12-13-23 - Initial Redlines

Lot 148
648 Duncan Creek Rd.
Lillington, NC 27546

The Brunswick Craftsman - RH

NEW HOME INC
STRUCTURAL ADDENDUM
SCOPE: STRUCTURAL ADDENDUM
RIGHT HAND

REAR ELEVATION (SLAB)
SCALE: 1/4" = 1'-0" ON 22x34, 1/8" = 1'-0" ON 11x17

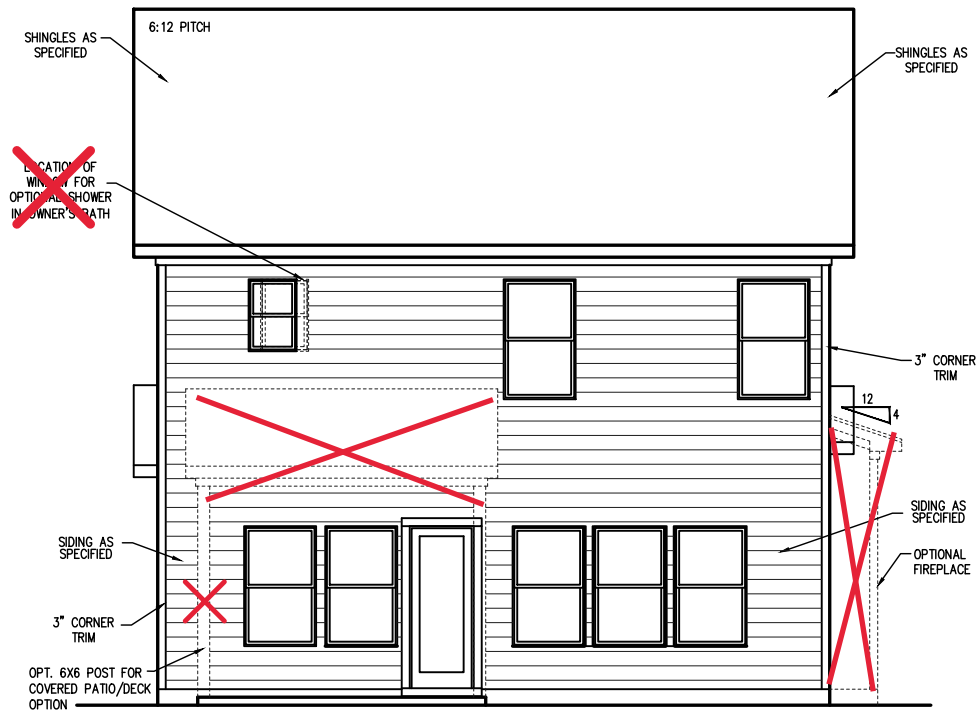
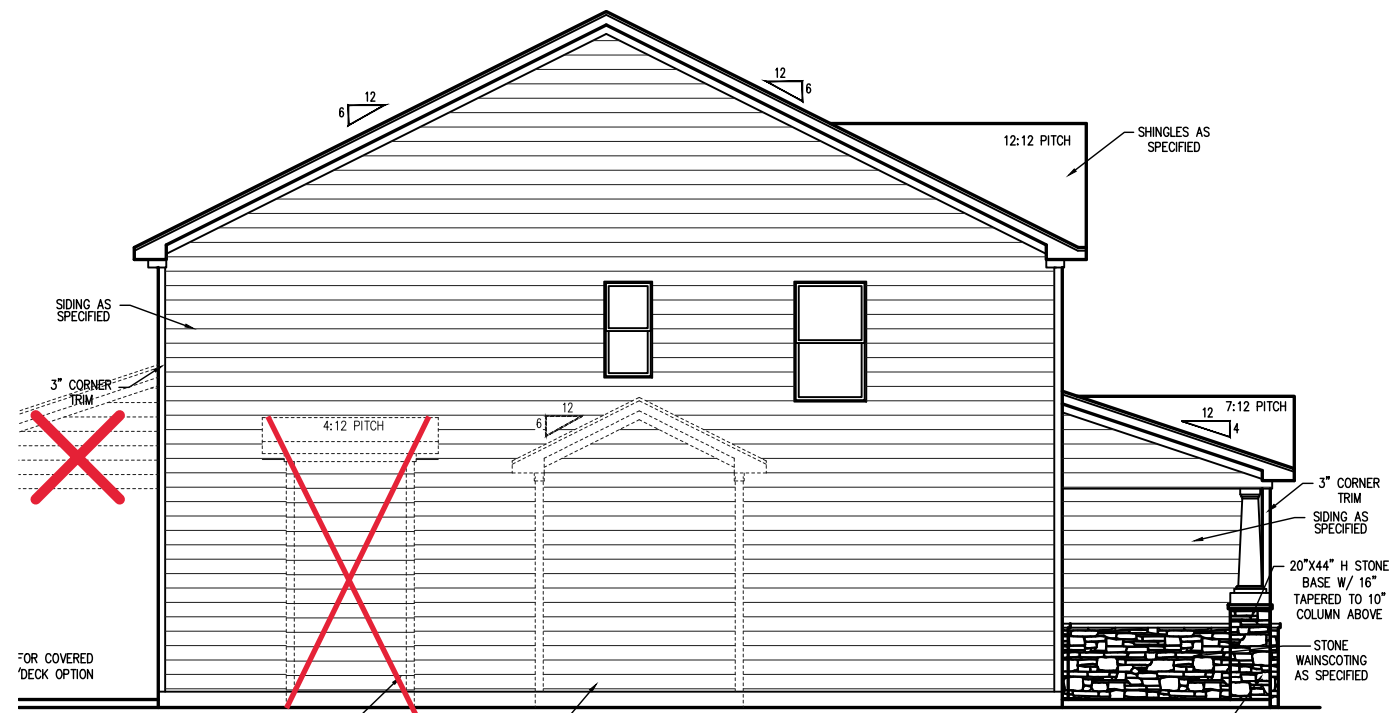
**Patio Only
No Cov. Porch**

**Patio Only
No Cov. Porch**

**Patio Only
No Cov. Porch**

OPTIONAL CAFE WINDOWS
RIGHT ELEVATION (SLAB)
 SCALE: 1/4" = 1'-0" ON 22x34, 1/8" = 1'-0" ON 11x17

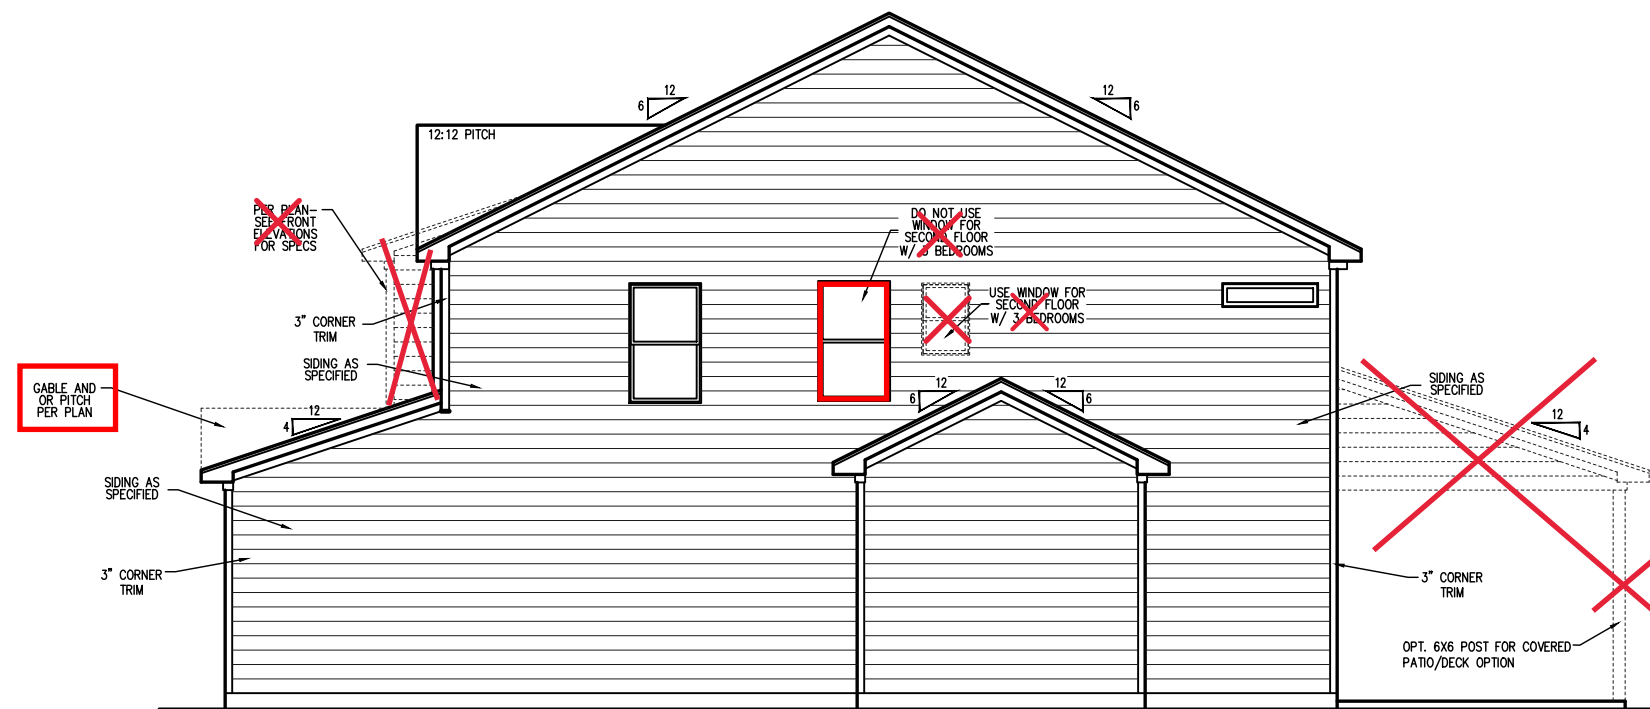
Patio Only
No Cov. Porch
